ADDENDUM NO. 2

BUILDING "R" TOILET ROOMS RENOVATION

NTD #2007-SH29-01

Pasadena City College
1570 E. Colorado Blvd.
Pasadena, California 91106

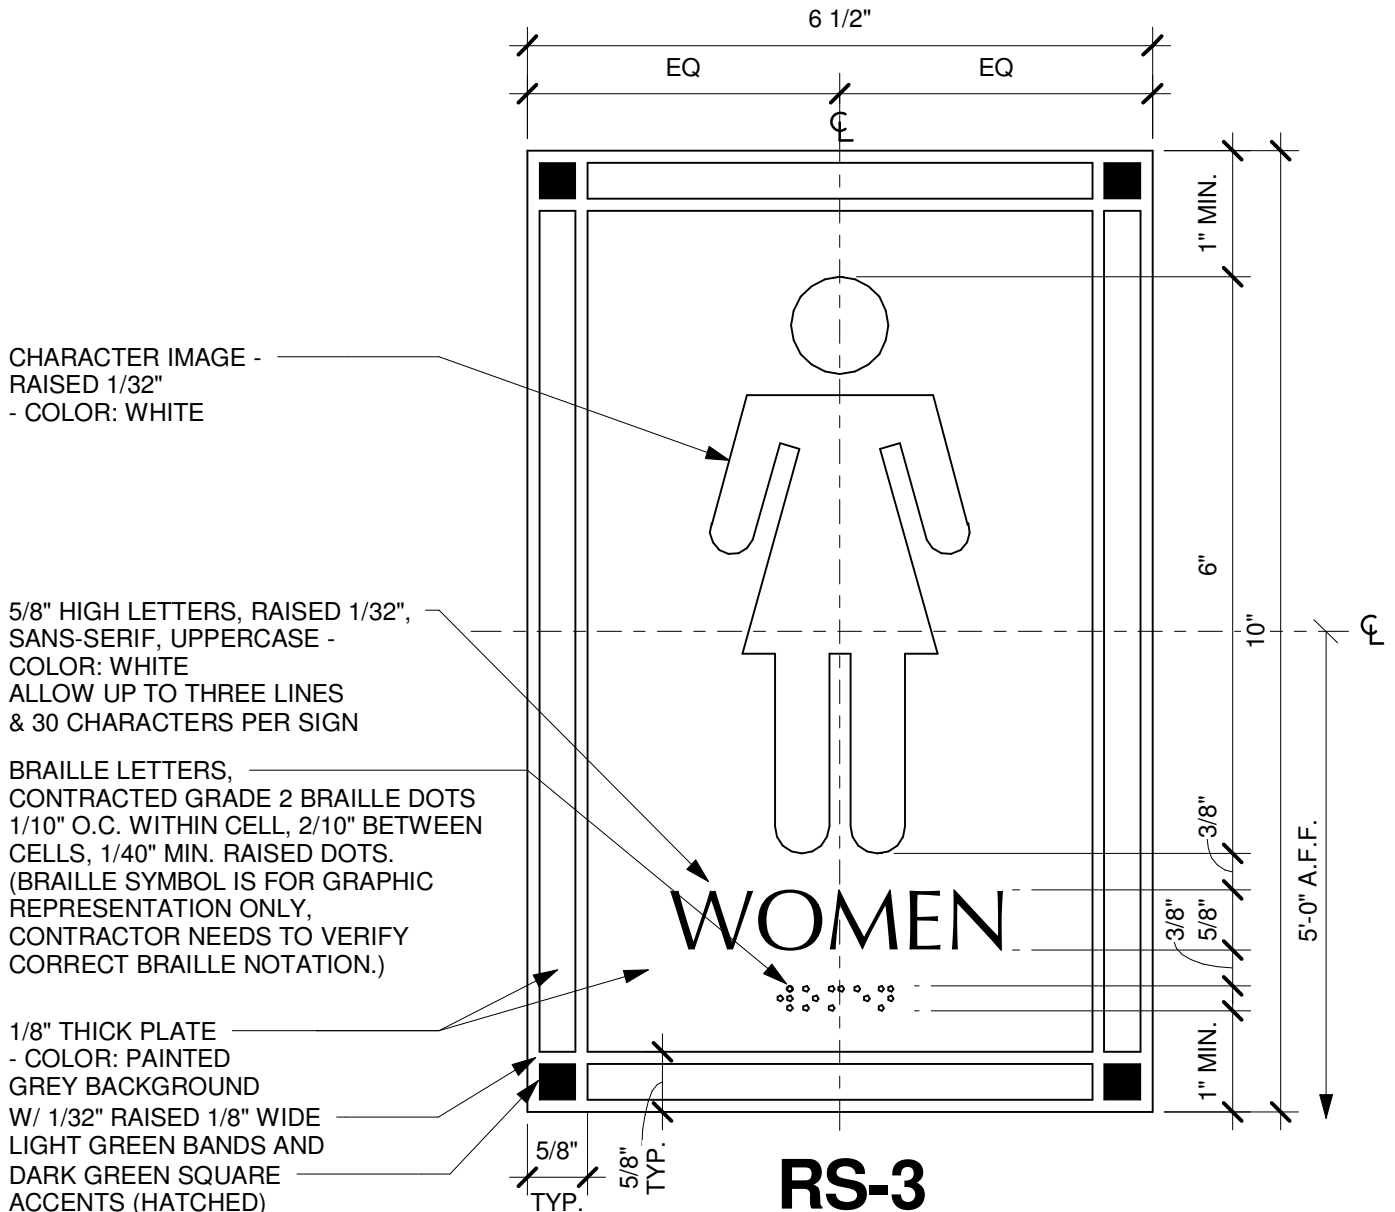
3.1.7.1. Add this attached drawing for reference to signage detail 9/A8.1.

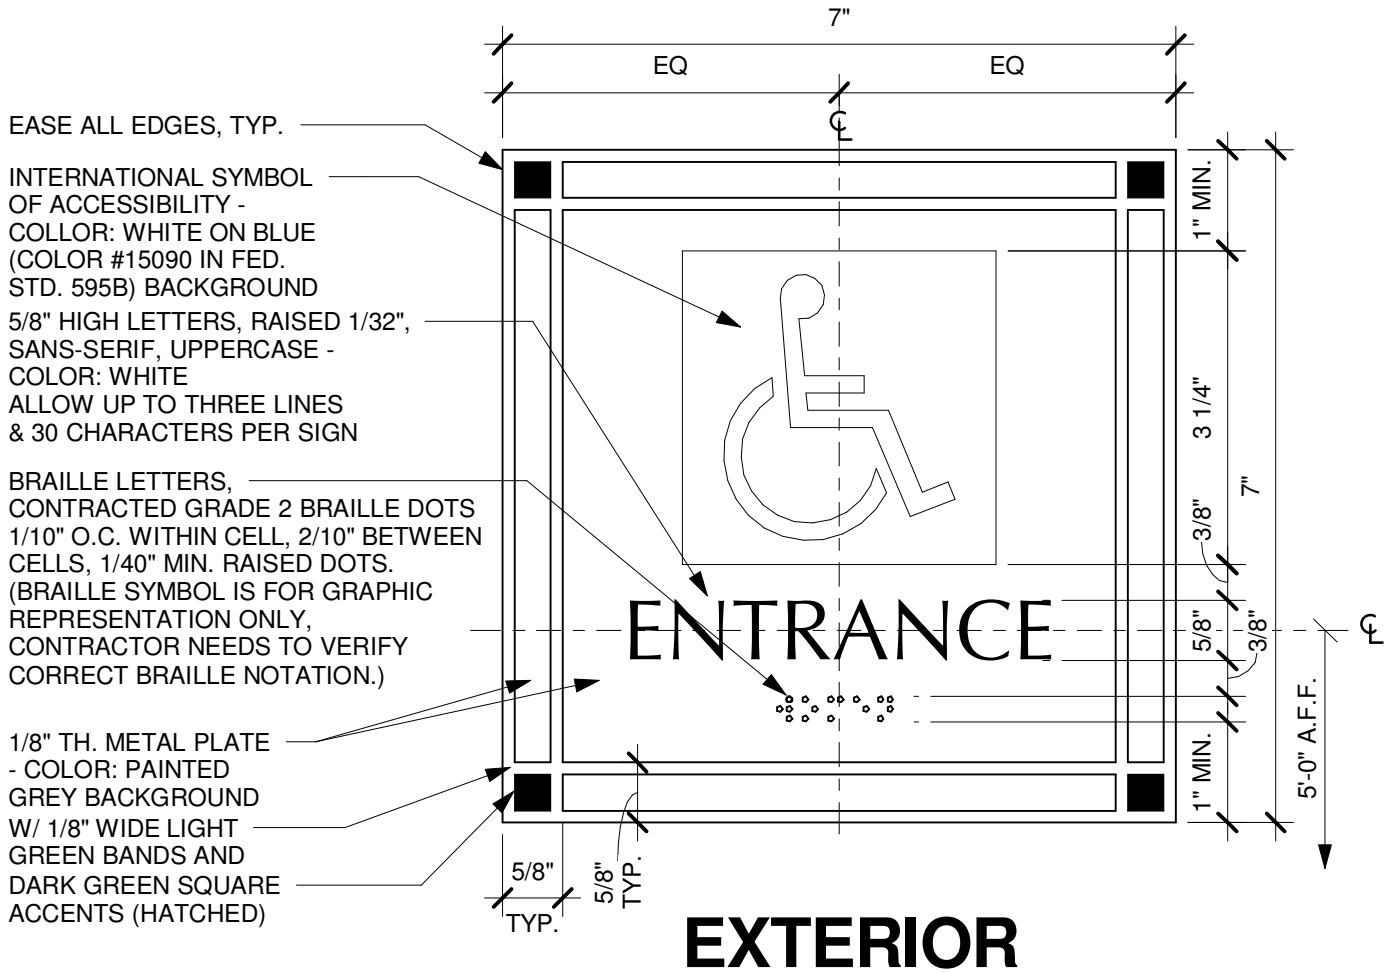
3.1.8.1. Add this attached drawing for reference to signage details 9 & 12/A8.1.

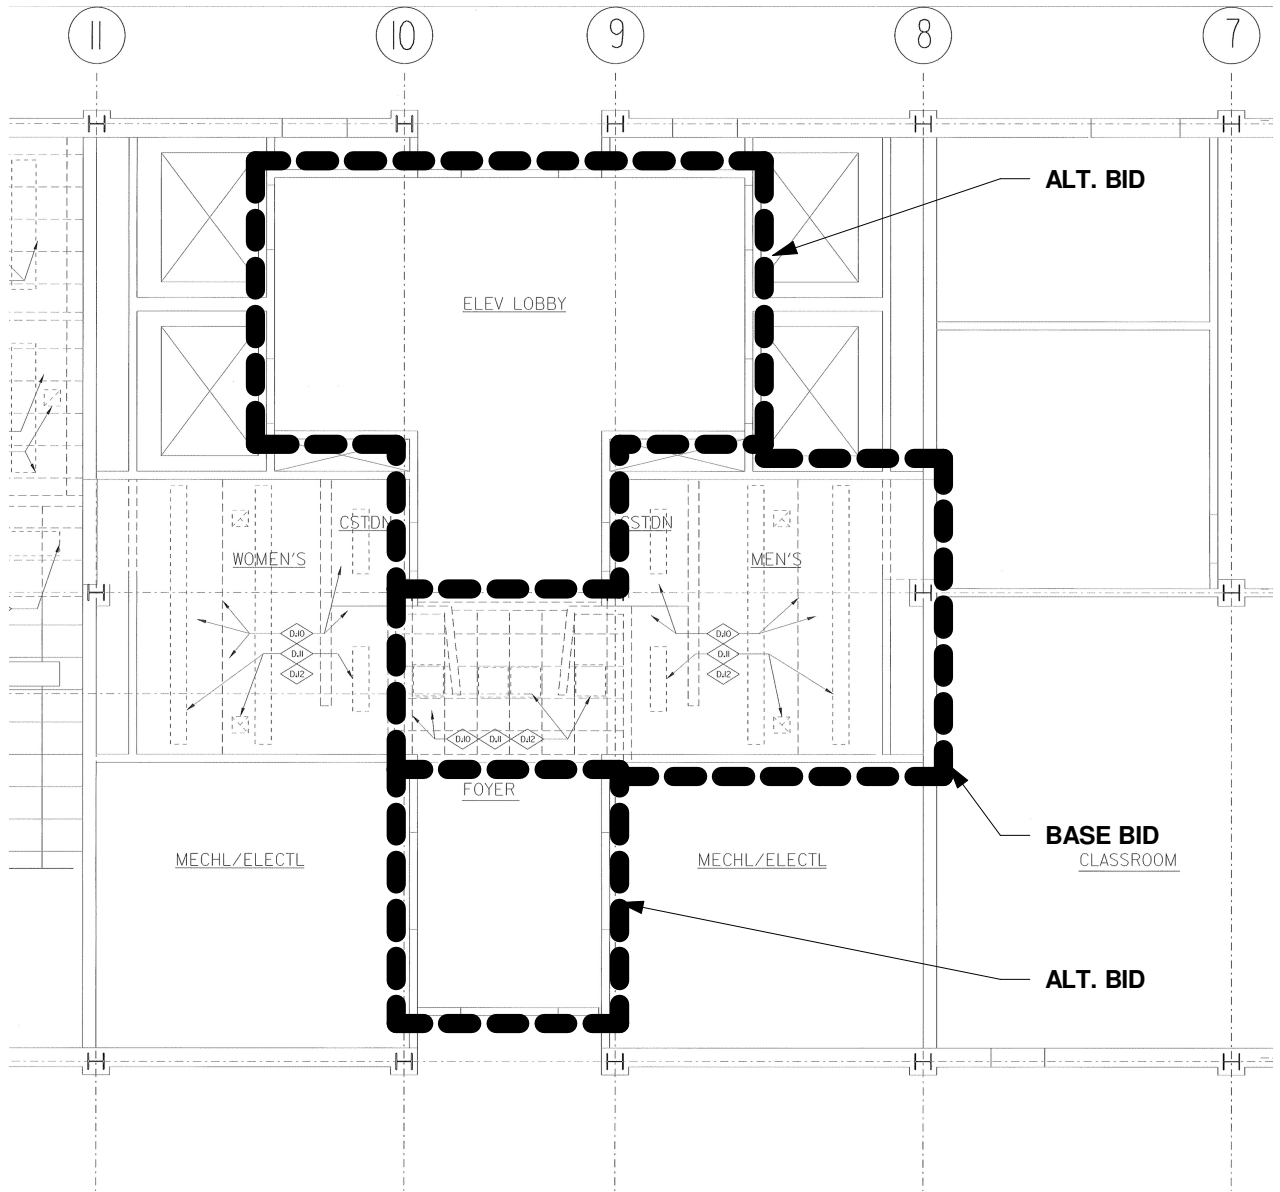
3.1.10.1. Add this attached drawings for reference to accessible entry signage at Grids 10/A and 9/C per drawing A3.1. Refer to detail 9/A8.1 for additional information.

SHEET REF:	D4.1
DOC. REF:	
CONTR. REF:	
DATE:	11/21/11
JOB NO:	2007-SH29-01
DRAWING:	AD2-A05

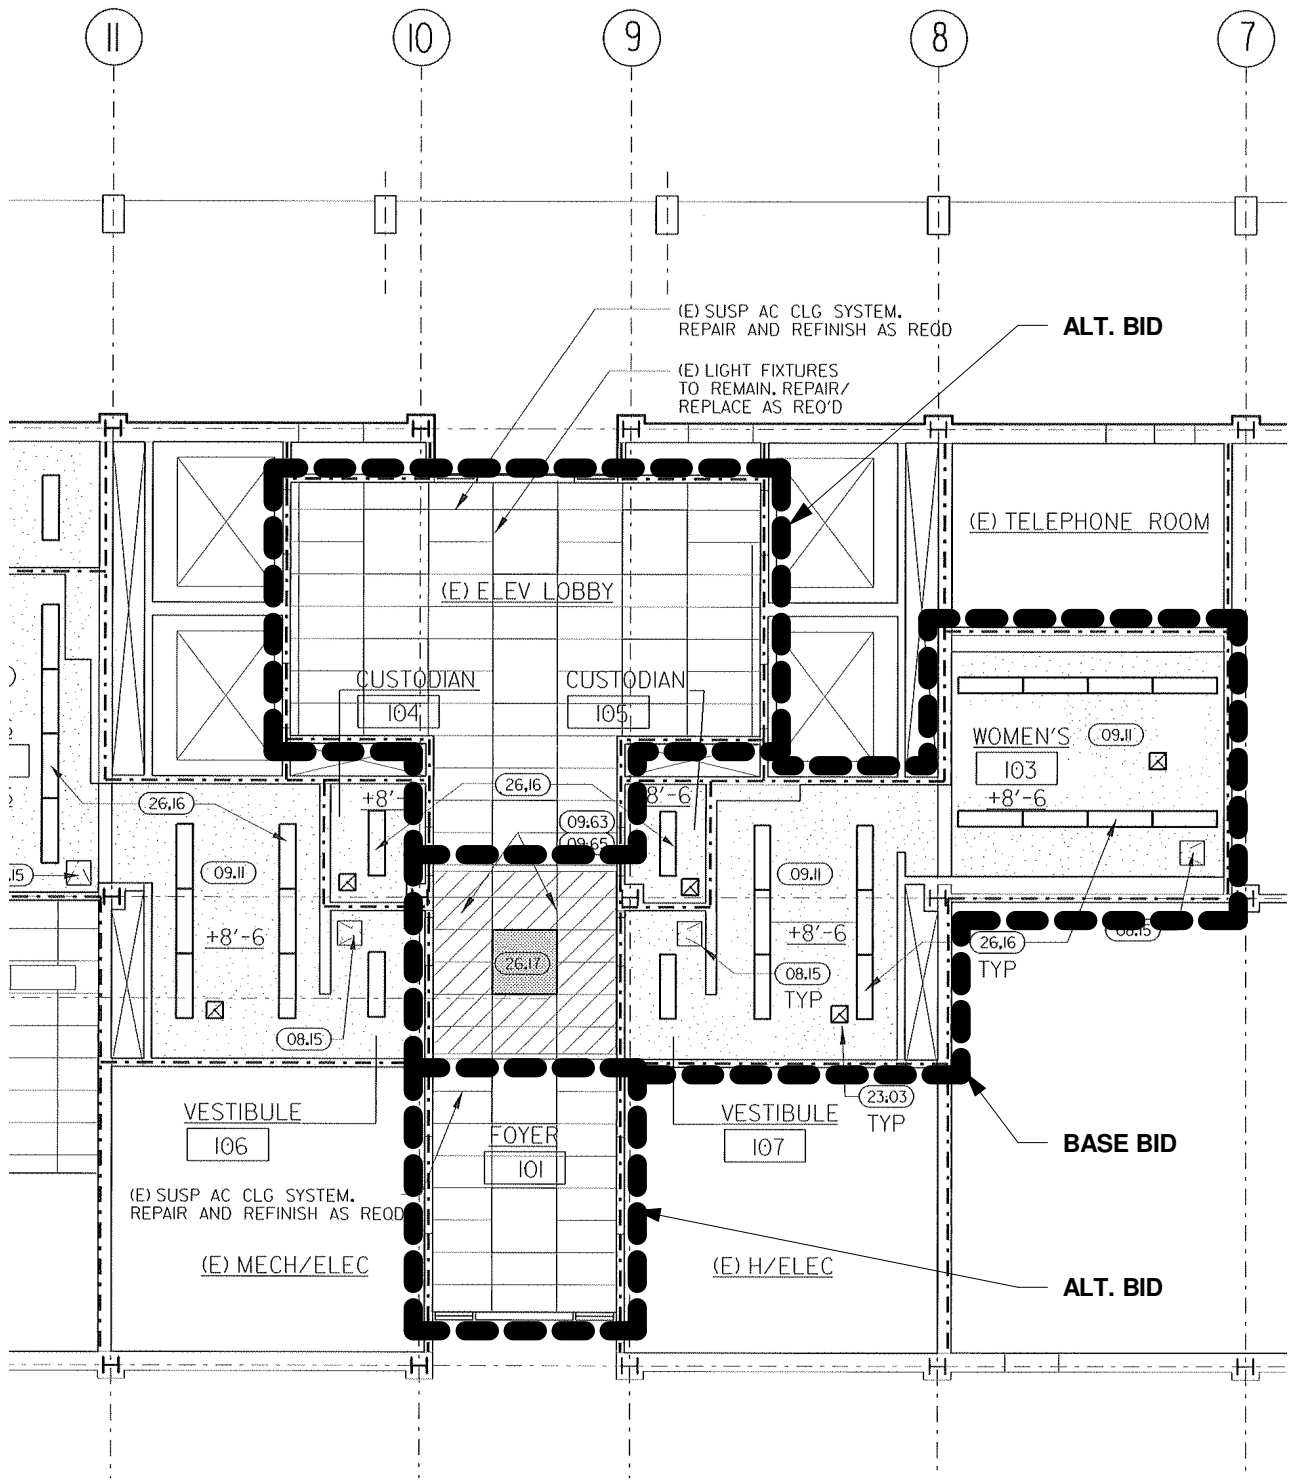
3.1.1.3. Revision to remove all existing ceiling tile and grid, and 4'-0" x 4'-0" light fixtures at elevator lobby and foyer.
